AMENDMENTS TO THE DRAWINGS

The attached sheets of drawings include changes to figures 1-6. These two sheets, replace the original sheets including figures 1-6.

FIG. 1
 (Prior Art)

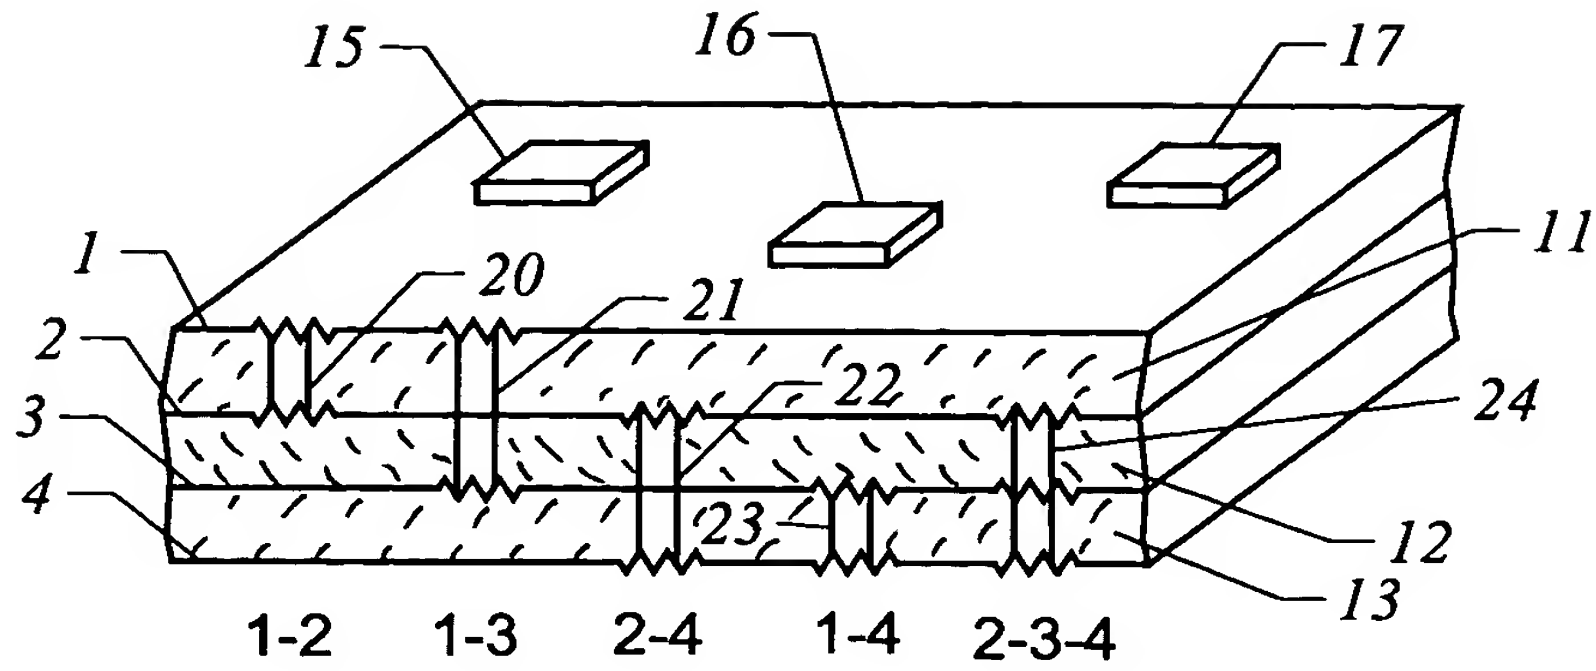
The Examiner has objected to the drawings as not being properly cross-hatched. Appended hereto are proposed drawing changes showing crosshatching of the sectional views.
